Date of Issue: March 31, 2017

Affected Publication: API Specification 6D, Specification for Pipeline and Piping Valves, Twenty-fourth Edition, August 2014

ERRATA 9

Page 35, **Section 11**, delete the text in the red box:

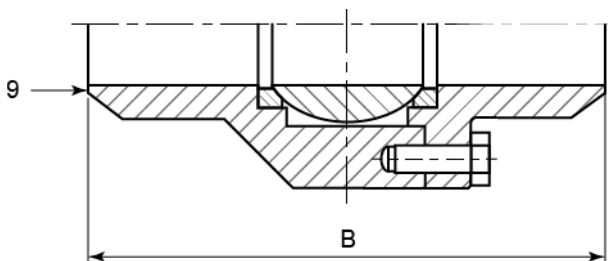
On valves whose size or shape limits the body markings, they may be omitted in the following order:

- 1) size,
- 2) rating,
- 3) material,
- 4) manufacturer name or trademark.

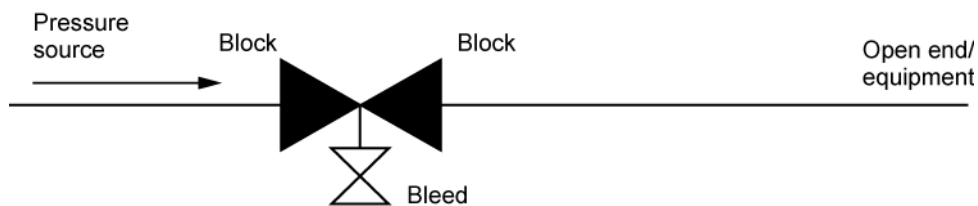
Page 57, **Figure B.14**, replace part B of the figure as follows:
